| GRADING PLAN | | | | | | |
|--------------------------------------------------------------|-------|---------|--------|-------|------|-----|
| BLACK EYED PEA RESTAURANT | | | | | | |
| ADDISON, TEXAS | | | | | | |

| WATER & SANITARY SEWER PLAN | | | | | |
| PRELIMINARY SUBMITTAL FOR REVIEW DAVID A. VILBIG P.E.# 67207 | | | | | |

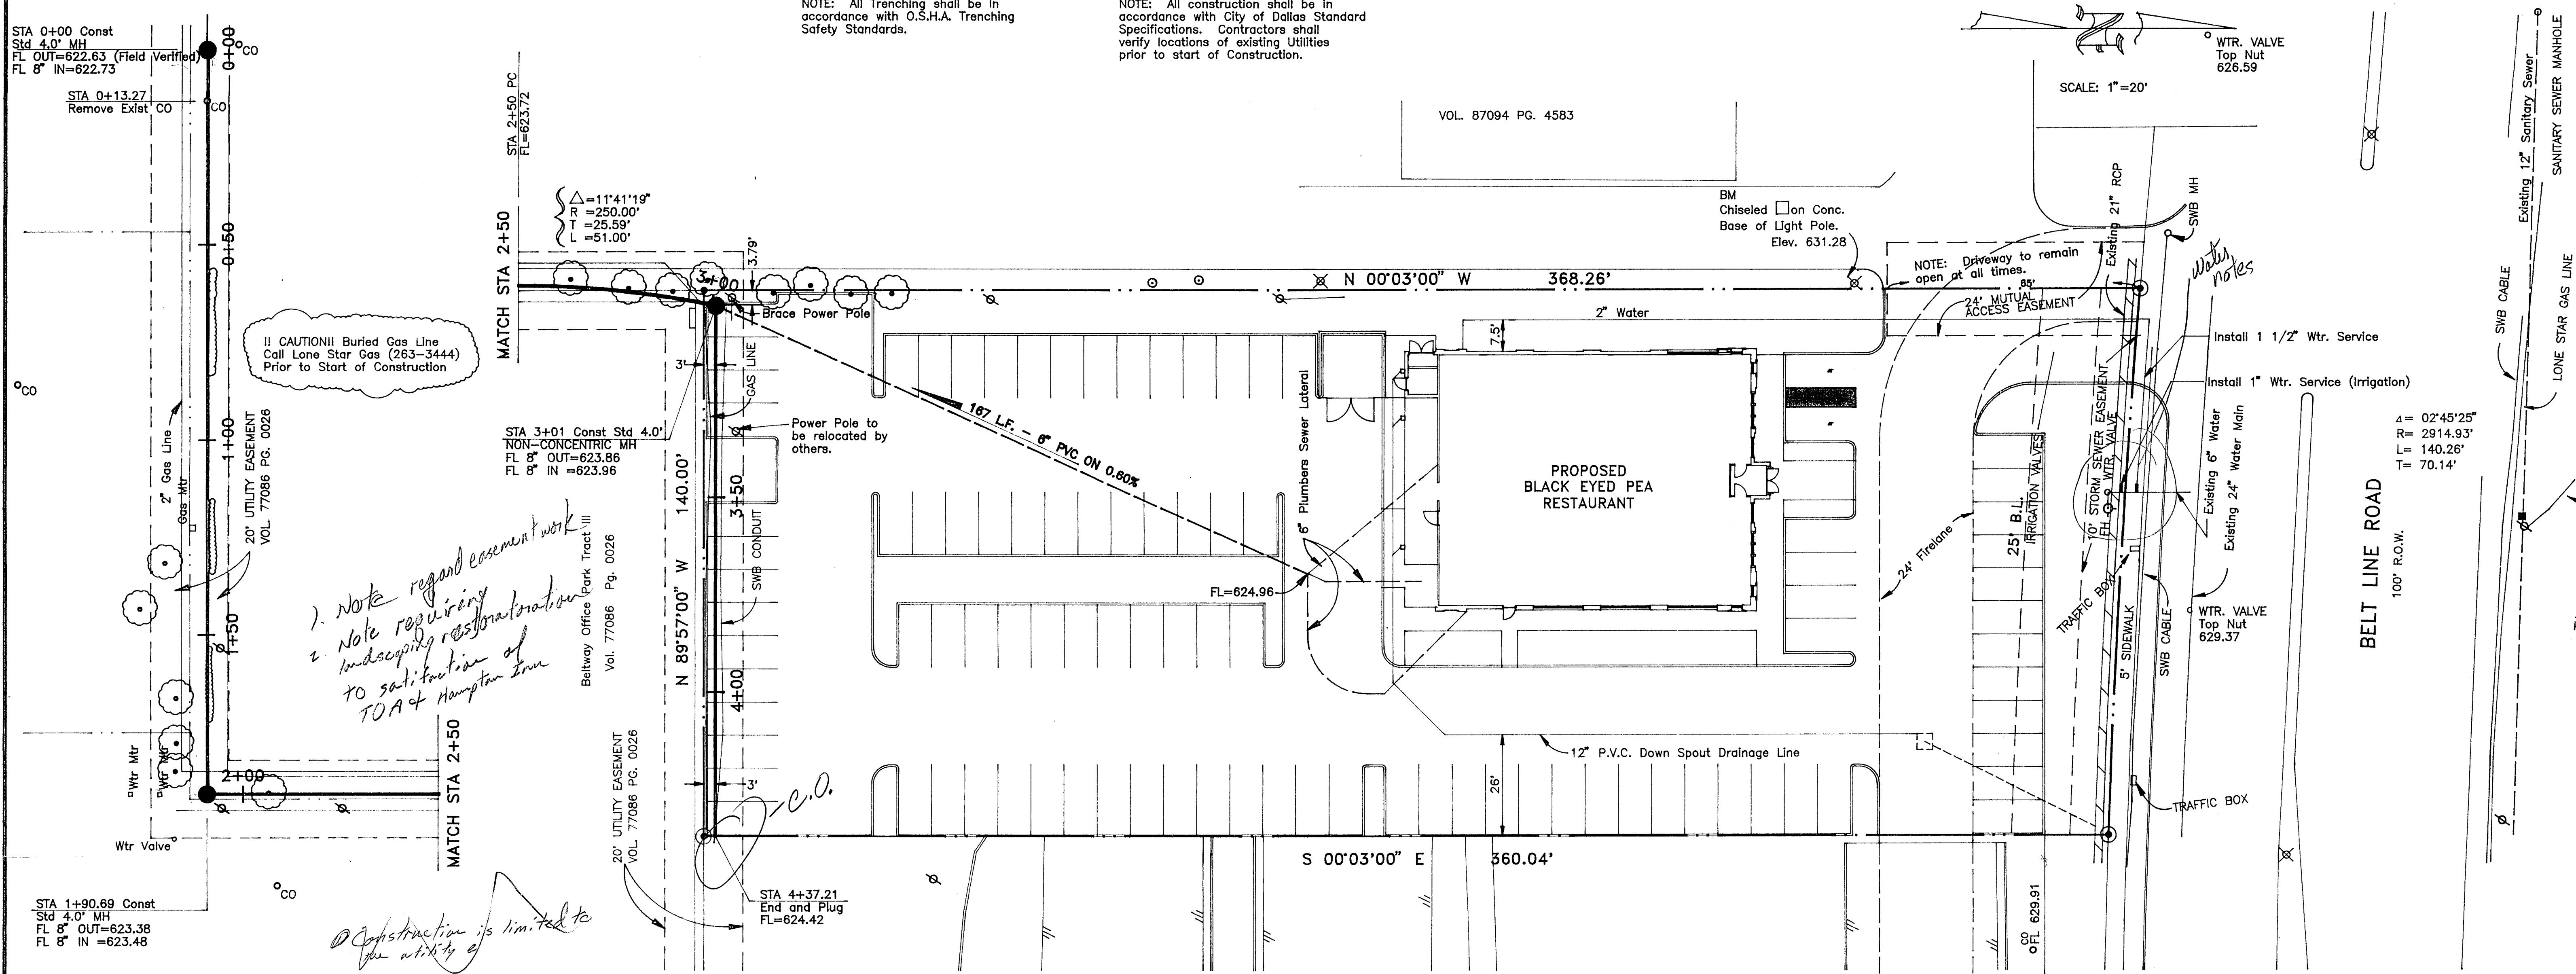
1. Note regard easement work
2. Note regarding landscaping restoration to satisfaction of TOA & Hampton Inn

Construction is limited to the utility
